Service Information

Category T	Repair Guidance	Ref. No. R056/13	Page 1 of 3
Coverage Distributor only Please inform your dealers		Date Issued July 16, 2013	
Please convey this information to your Director General Manager Warranty Dept. Parts Dept. Training Dept. Field Rep.		Date Revised	
Applicable Model CX-5 (KE) and Mazda6 (GJ) Sedan equipped with Theft-Deterrent System		Applicable Countries or Specifications Worldwide

Subject: Noise from right rear of vehicle when closing rear door/trunk lid or driving on rough road.

Theft-Deterrent Horn

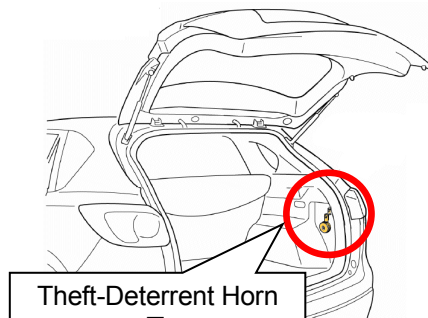
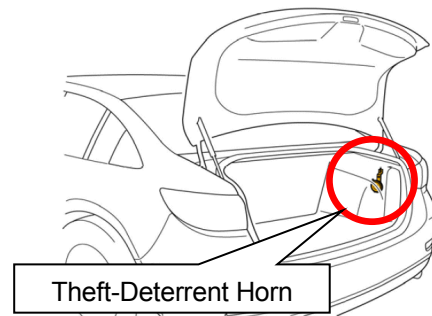
The noise may be caused by the theft-deterrent horn bracket which resonates with the body panel when vibration is given to the vehicle.

A EPT sealer has been attached to the theft deterrent horn to eliminate the noise.

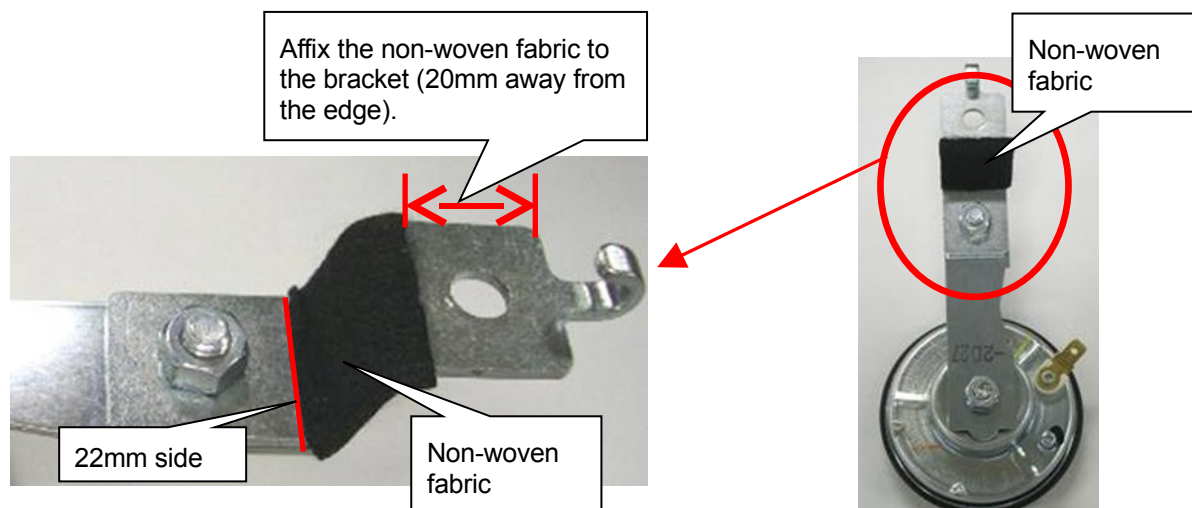
4. Affix the non-woven fabric to the horn bracket face where it touches with the body panel as shown in below figure.

5. Install the theft-deterrent horn with the installation bolt.

Tightening torque: 9-12 N-m (92-122 kgf-cm, 80-106 in-lbf)
